PART 21 REPORT - DEFECTIVE BARTON DIFFERENTIAL PRESSURE SWITCHES

**SUBJECT: Notification of Defect**

**Model 288A, 289A, 580A and 581A Differential Pressure Switch Defect**

DOCUMENT NO.: 210052426.01

**MODEL 288A/289A SWITCH OPERATING MECHANISM MOCKUP**  
**(Model 580A/581A Switch Operating Mechanism is similar)**

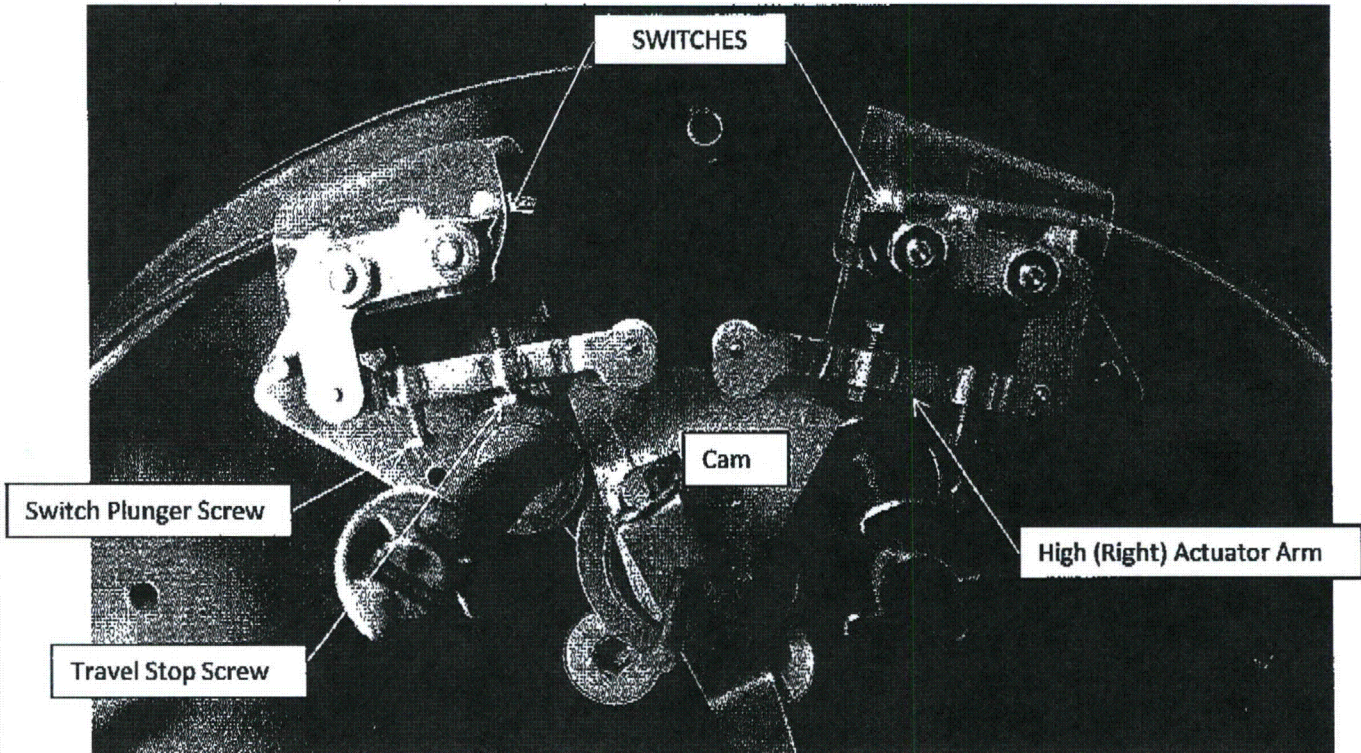
Testing performed to evaluate the significance of the of the non-conforming condition revealed that the force of the miniature switch internal operating features can cause the thread "locking" material to be displaced allowing an undersized plunger screw to change its set position resulting in a change in the point where the switch will actuate (change in contact position). Screws with conforming threads did not demonstrate the same issue. The maximum change in screw position observed during this testing effort equates to a switch set point change of approximately 8.4% of the instrument's factory calibrated span.

Cameron recommends that utilities perform increased switch set point verifications on the instruments affected by this notification. It is not possible to determine which of the switches might have nonconforming switch plunger screws. Therefore, Cameron recommends that new switch actuator arm assemblies be replaced on any unit that is evaluated to be a concern by our customers. These replacement parts are available in the Cameron stock system and will be supplied free of charge for any of the products included within the scope of this notification. The P/N's for the replacement assemblies are identified on the following page.
